Re: Interbridges Site, New Brighton Road, Emsworth (LPA ref. APP/24/01010)

Bellamy Roberts has been instructed by PNH Properties to provide a written response to the LLFA's consultation comments dated 17th April 2025, which are enclosed for reference.

Proposed employment development, with associated access, parking, yards and landscaping. at Interbridges Site, New Brighton Road, Emsworth(Application No. APP/24/01010)

Topographical Survey

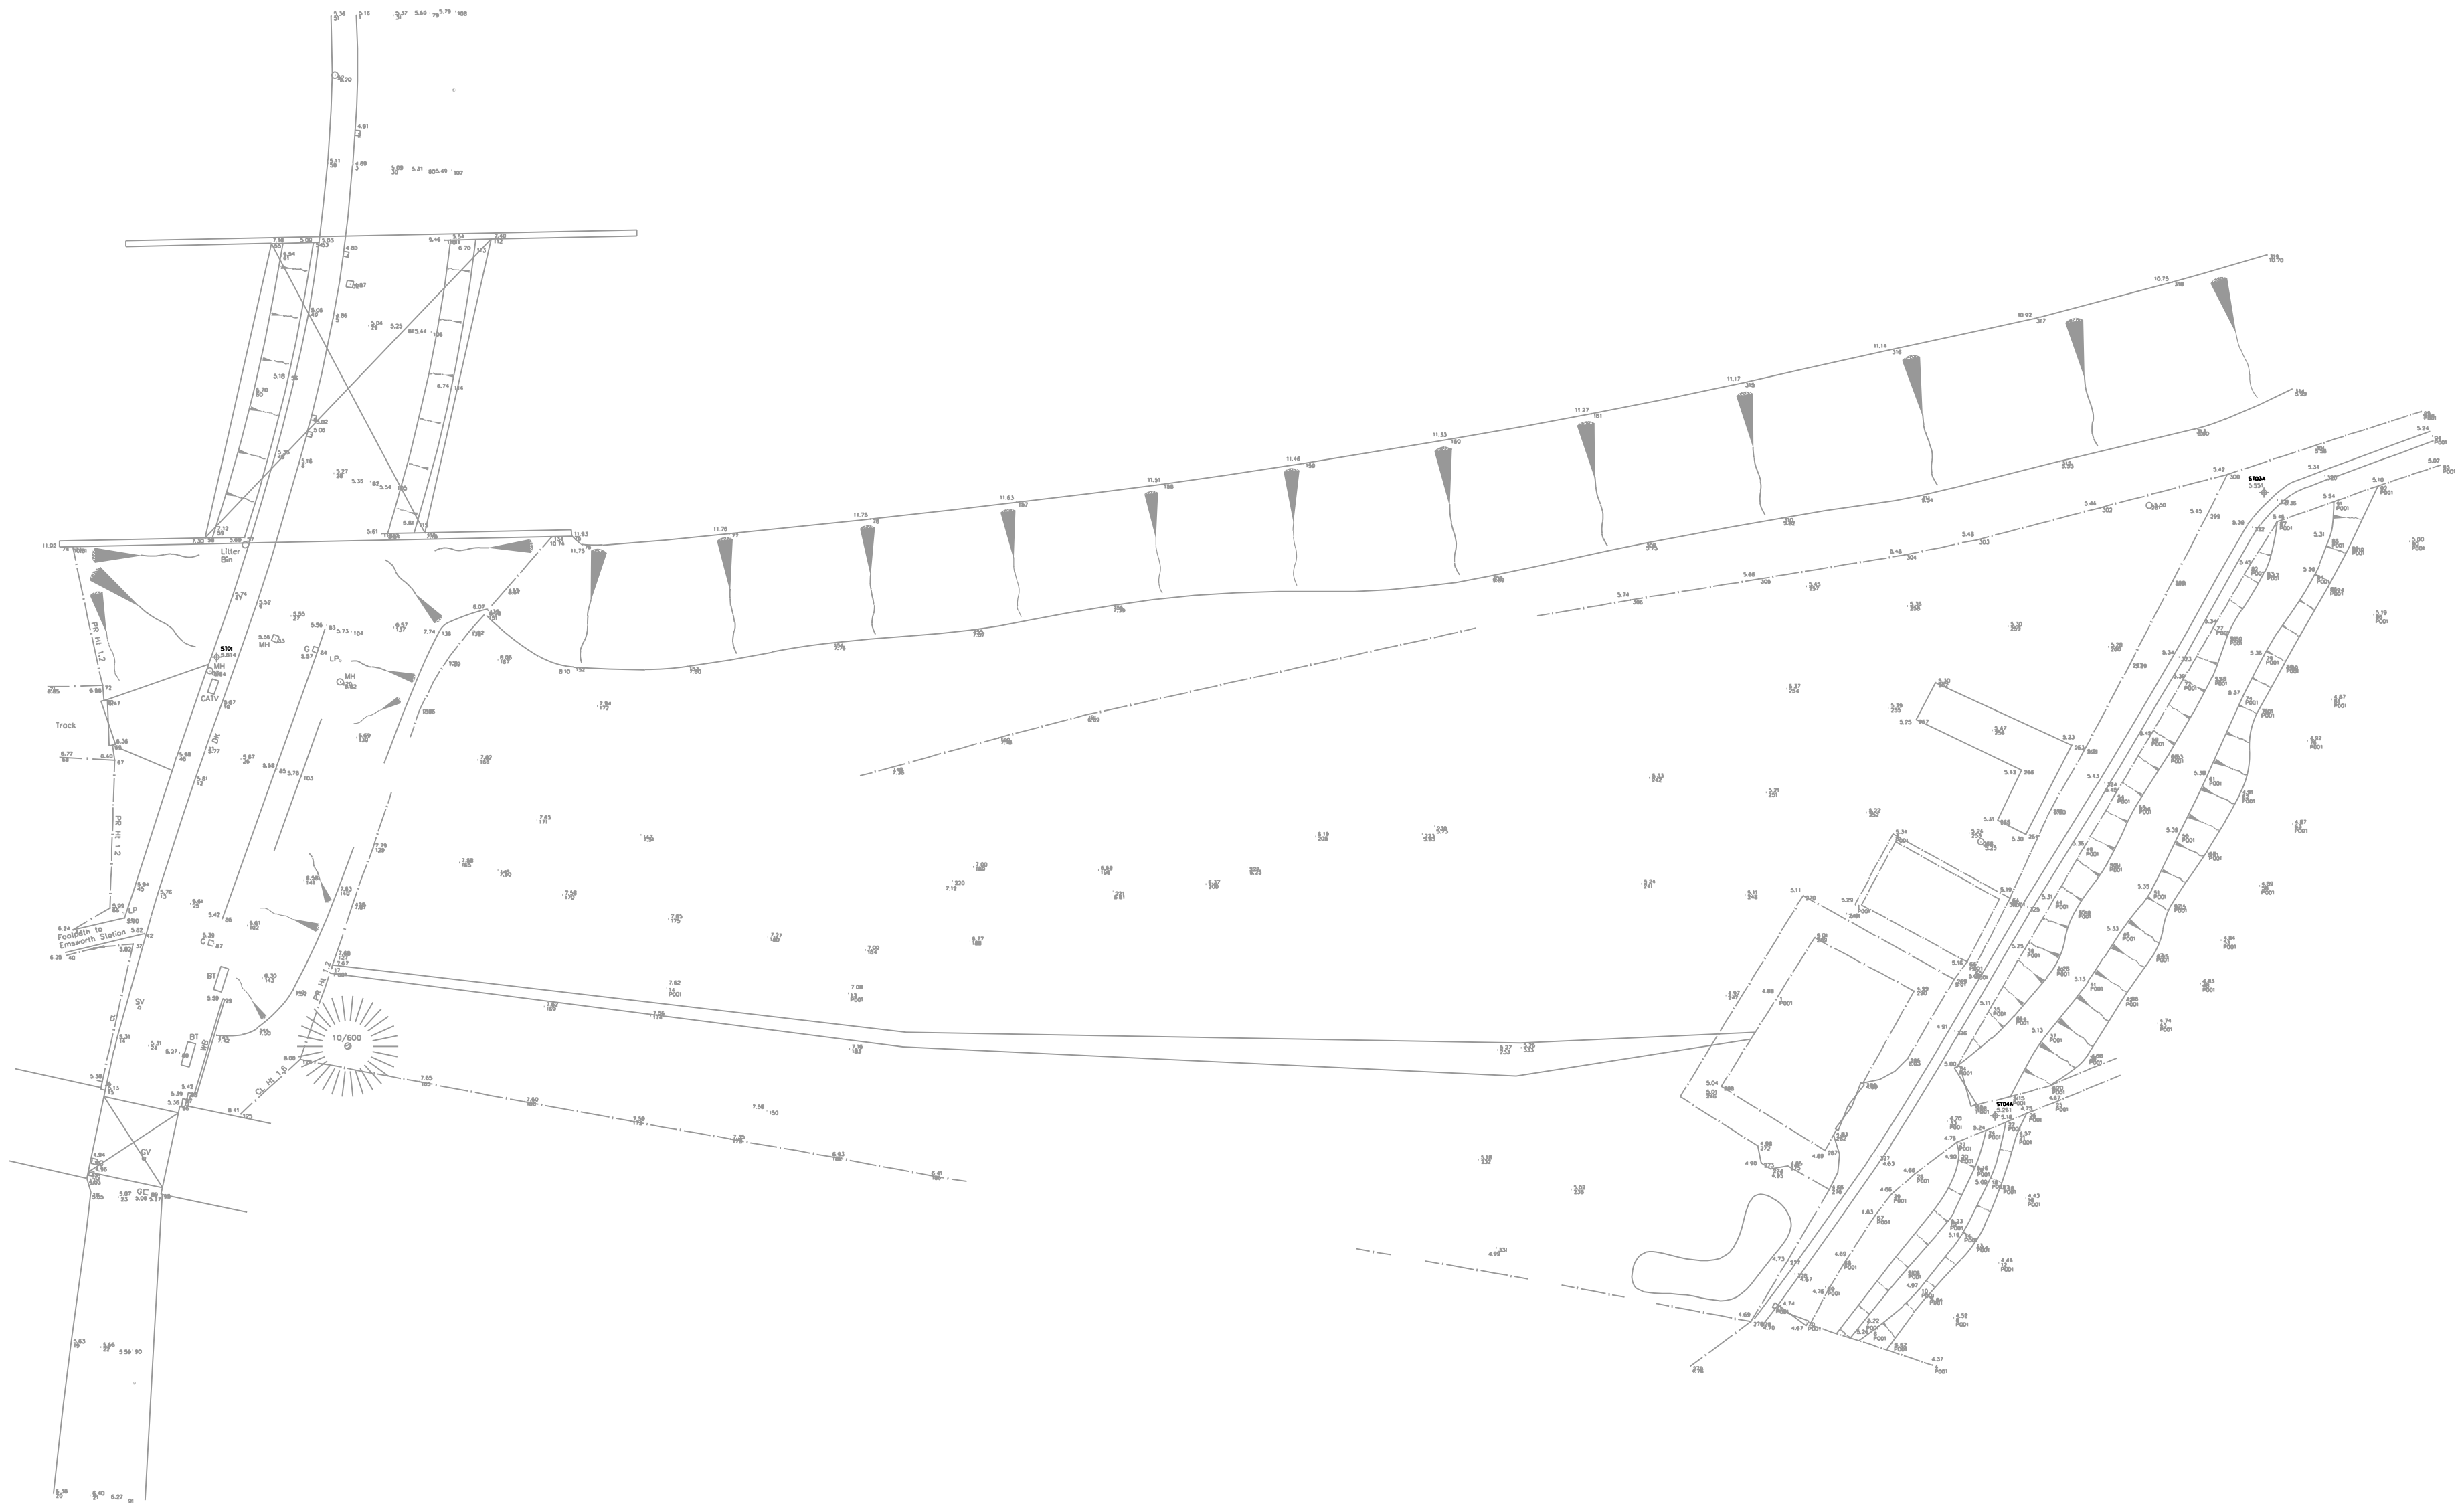
Our previous comment regarding the proposed discharge point referred to the proposed discharge into the southern water sewer being different from the existing site discharge. The above document states that the existing site does not discharge to the river to the East of the site as we had assumed but no explanation has been provided for the existing site surface water point of discharge. Non-Statutory technical Standards for Sustainable Drainage recommend drainage systems should be designed to mimic natural drainage flow pathways. The NPPF hierarchy of drainage options states discharge to a watercourse is preferred over discharge to public surface water sewer. The applicant should provide explanation of the existing site discharge point, whether discharge to the river has been considered and reasoning for why this is not considered to be appropriate as evidence of compliance with the NPPF. The drainage scheme proposes to discharge below greenfield runoff rate but to a different location.

We await confirmation of agreement with Southern water for the proposed discharge location and rate.

The enclosed topographical survey shows the site levels fall towards the east. Along the eastern boundary, the survey shows the presence of a bank. This would restrict the flow of surface water runoff from the site entering the watercourse further to the east.

It is likely therefore that the pre-development discharge point is along the footpath that connects to Seagull Lane.

Therefore, a connection to the Southern Water sewer is proposed. Given the site levels, a pumped solution will be required.
